Access Compliance Report

Public Rights-of-Way

(Curb Ramps)

Intersection ID: 27847	Main Street: PARADISE RIDGE RD	Cross Street: NORTH COMMUNITY HOUSE RD	Location: SE
ADA ID: AD56A493C257	Ramp Type: BlendTrans2	Initial Pass/Fail: Pass	Overall Compliance: No
Severity Score: 0.25			
Codes/Mitigation Info/Possible Solution		Field Measurements/Component Compliance

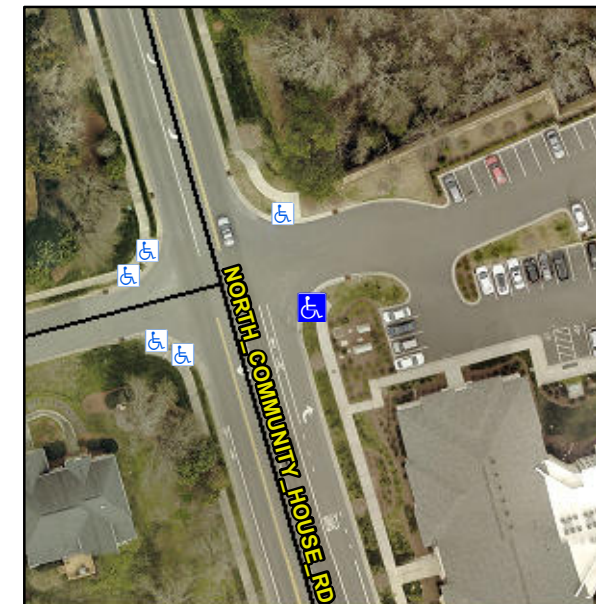
Compliance	Description	Data	Compliance	Description	Data
N/A	Ramp Length (in)	134.0	Yes	BlendTrans Slope (%)	3.3
Yes	Ramp Width (in)	48.0	No	BlendTrans XSlope (%)	2.4
N/A	Flare Type LT	Sloped	N/A	Flare Type RT	Sloped
N/A	Flare Slope LT (%)	N/A	N/A	Flare Slope RT (%)	N/A
N/A	Flare Traversable LT?	No	N/A	Flare Traversable RT?	No
N/A	Landing Length (in)	N/A	Yes	DWS Provided?	Yes
N/A	Landing Width (in)	N/A	Yes	DWS Contrast?	Yes
N/A	Landing Slope (%)	N/A	Yes	DWS Length (in)	24.0
N/A	Landing X Slope (%)	N/A	Yes	DWS Full Width?	Yes
N/A	Landing Curb? (Y/N)	No	Yes	DWS Offset (in)	1.0
N/A	Shared Landing?	No			
Yes	Gutter Ponding?	No	Yes	Gutter Slope (%)	2.8
Yes	Gutter Lip Ht (in)	0.0	Yes	Gutter X Slope (%)	1.7
N/A	Painted X Walk1?	No	N/A	Painted X Walk2?	No
	X Walk 1 Direction	To NE		X Walk 2 Direction	To NW
	X Walk 1 Width (in)	N/A		X Walk 2 Width (in)	N/A
	X Walk 1 Slope (%)	3.2		X Walk 2 Slope (%)	2.3
	X Walk 1 X Slope (%)	4.3		X Walk 2 X Slope (%)	1.6

N/A	Ramp inside XWalk1?	N/A	N/A	Ramp inside XWalk2?	N/A
	Road Slope (%)	3.2		Clear Space?	Yes
	Road X Slope (%)	4.4	N/A	Clear Space to XWalk (in)	N/A
Yes	Any Obstructions?	No	Yes	Storm Grate/Utility Hazard?	No
	Obstruction Type			Storm Grate/Utility Type	
		N/A			N/A
			Yes	Surface Condition? (G/P)	Good
			N/A	Curb Slope (%)	0.4

Remove & Replace Curb Ramp With Two New Directional Ramps or Equivalent.
